**INVITATION FOR BID NO. 836-8207.001**  
**Paw Paw Lake Area Wastewater Treatment Plant**  
**West Clarifier Improvements**

**ADDENDUM 002**

June 19, 2025

- B. The Schedule is as follows **(Addendum 002, Issued on 06-19-2025)**:

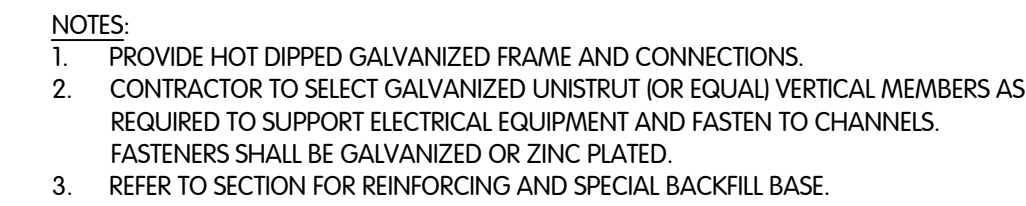
- C-410 - Bid Form for Construction Contracts
  - Updates work items.
- 09880 – Protective Coating for Concrete
  - Updates approved coatings and coating system requirements.
- 15211 – Small Piping and Valves
  - Updates manhole valve schedule.

Mark	Size (in.)	Fitting	Service	Operator	Drawing No.
<b>Plug Valves</b>					
West Manhole Valve 1	12	F	NPW	MOI	C-0.3
West Manhole Valve 2	18	F	NPW	MOI	C-0.3
East Manhole Valve 1	12	F	NPW	MOI	C-0.3
East Manhole Valve 2	18	F	NPW	MOI	C-0.3

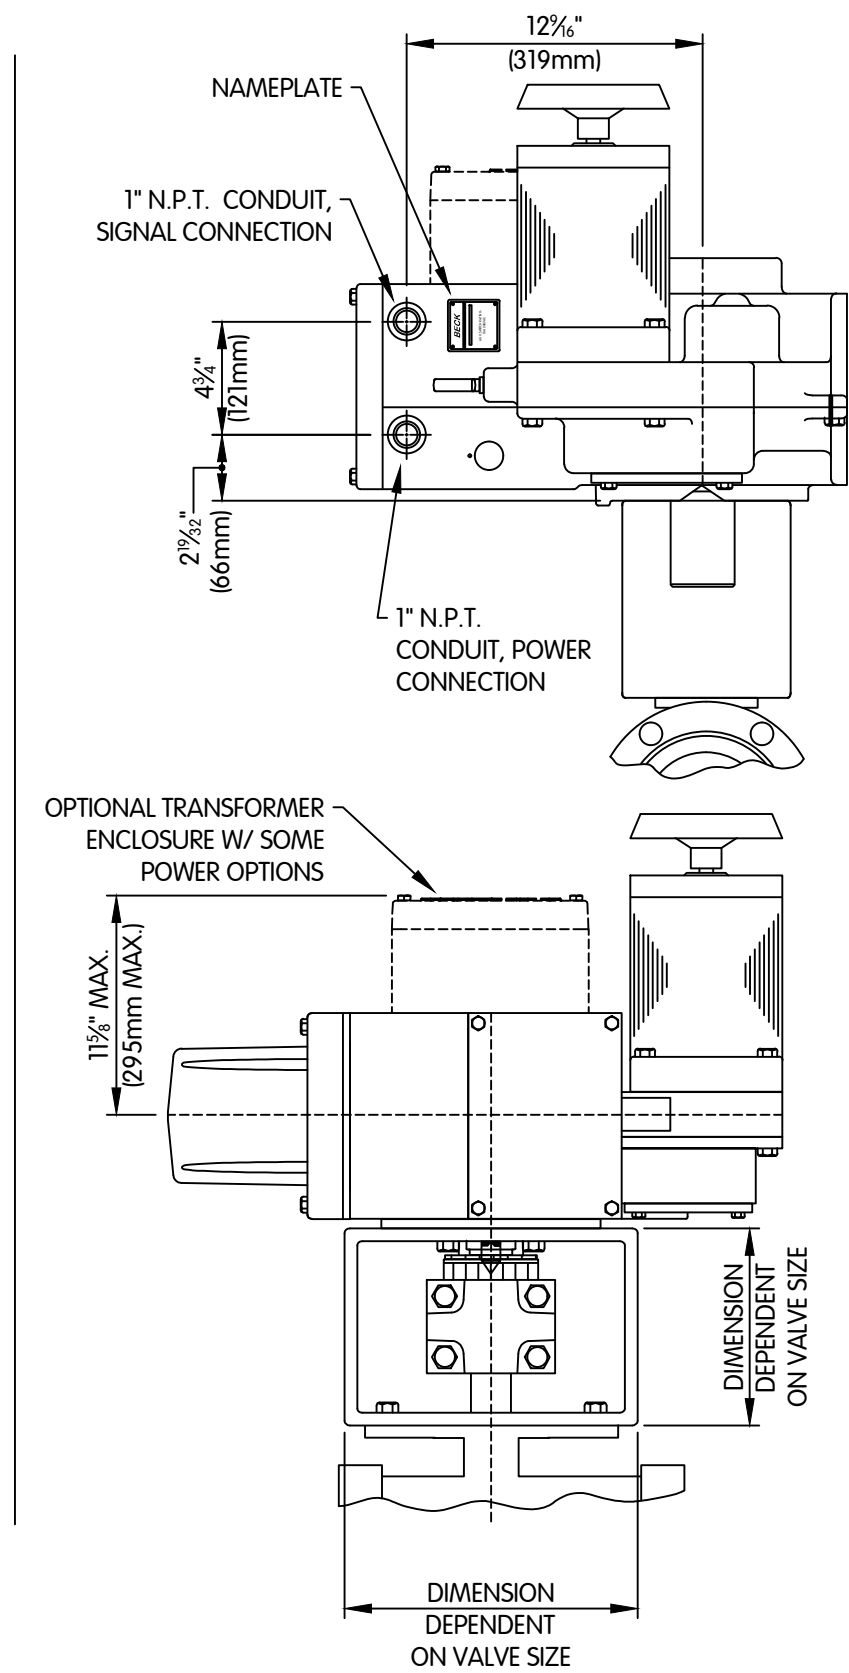
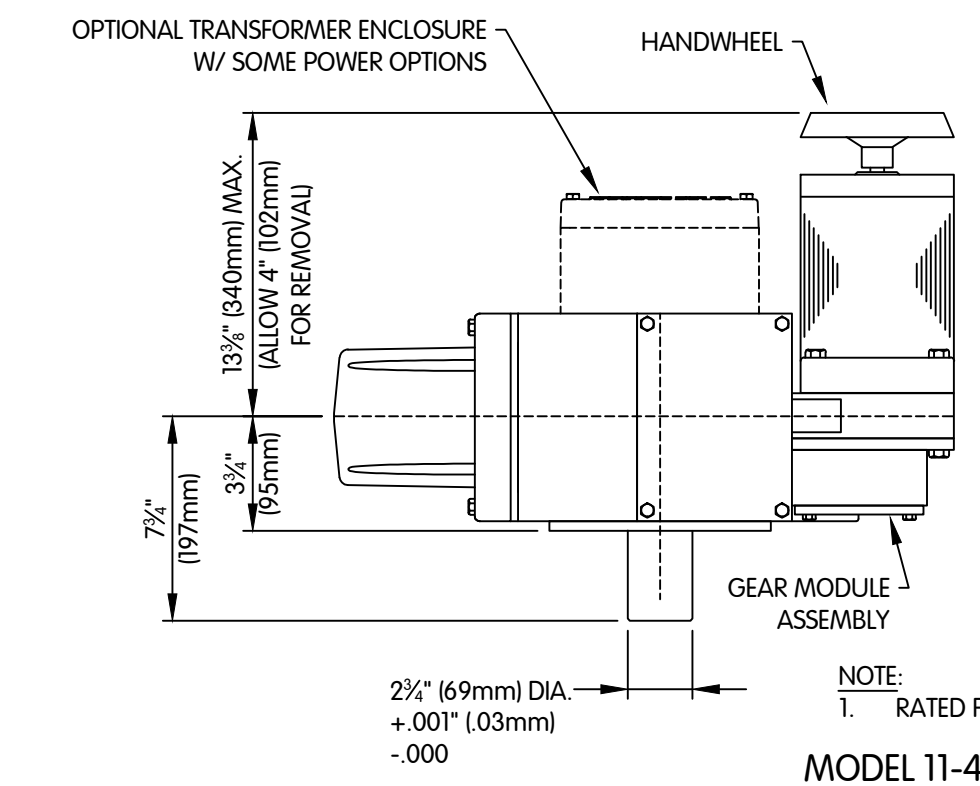
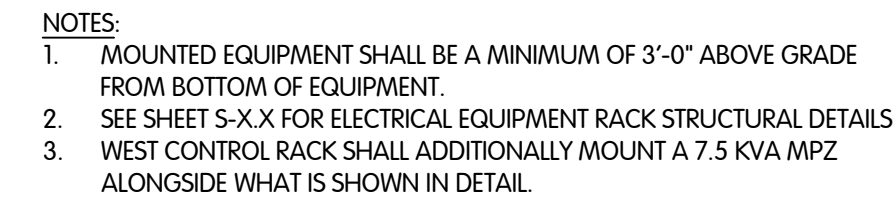
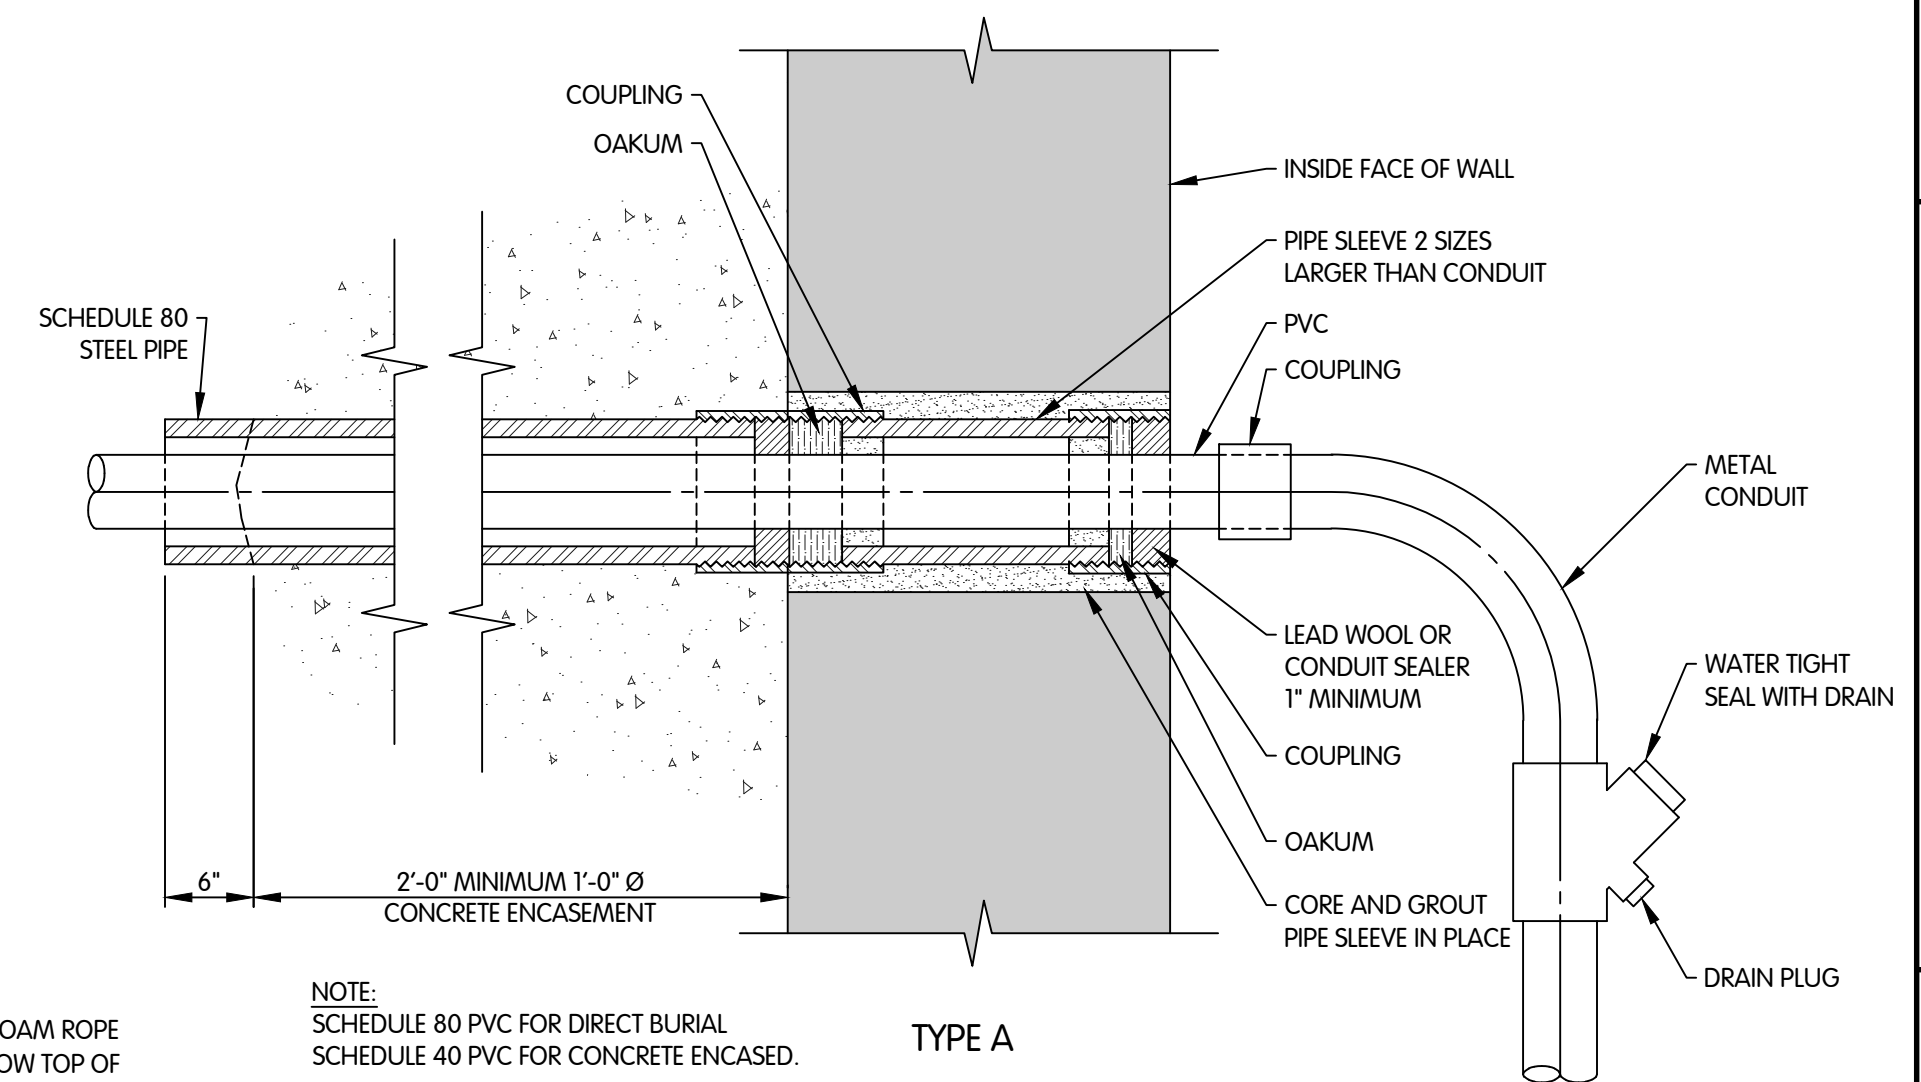
Q: On Sheet E-2, the Typical Clarifier Schematic shows outputs "To PLC". Will these be installed?

- Sheet E-2
  - Removes PLC set-up.

A: This will not be installed. Please see addendum #2 for the removal of these outputs to PLC.
